ADDENDUM NO. 4

Date of Issue: February 26, 2024

To all prospective bidders of record on the Work titled: **Biosolids Handling Facilities and Odor Control Improvements**

WAS PUMPS - P&ID	
SCALE	
JOB NO	20056
DATE	DECEMBER 2023
SHEET OF	---
	I-700

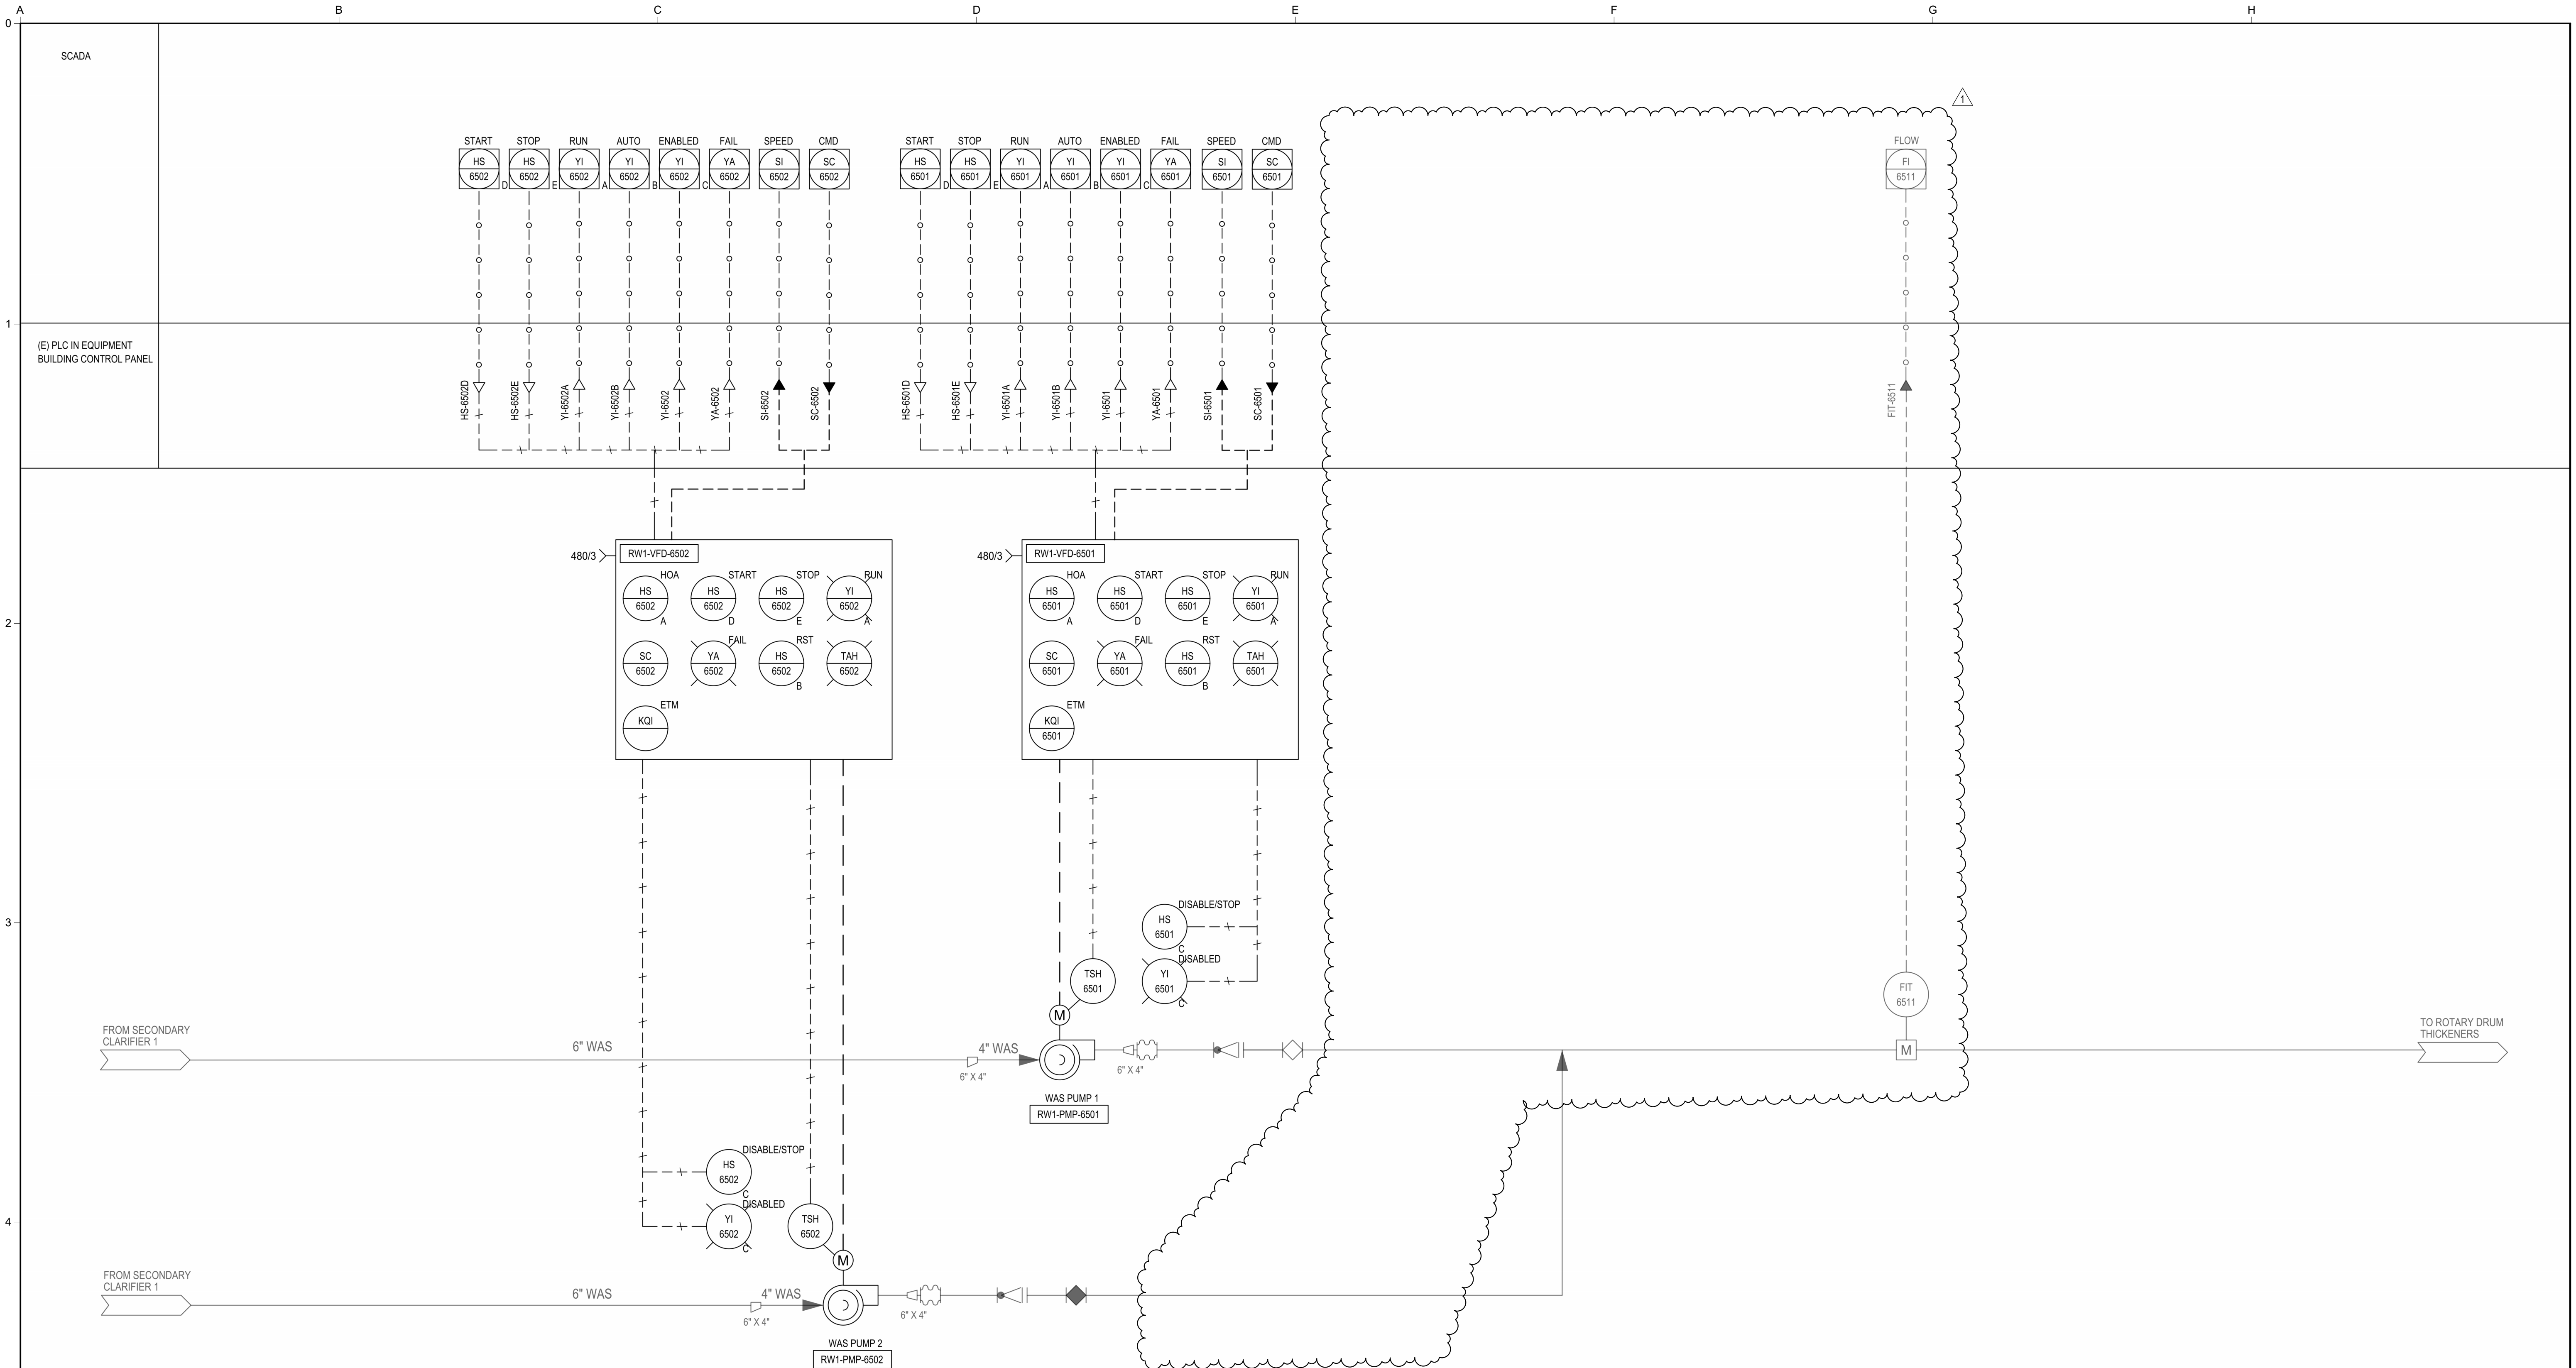
Sheet I-700 WAS PUMPS – P&ID

Replace Sheet I-700 WAS PUMPS – P&ID in its entirety with the revised Sheet I-700 WAS PUMPS – P&ID attached to this addendum. Changes are noted on the drawing.
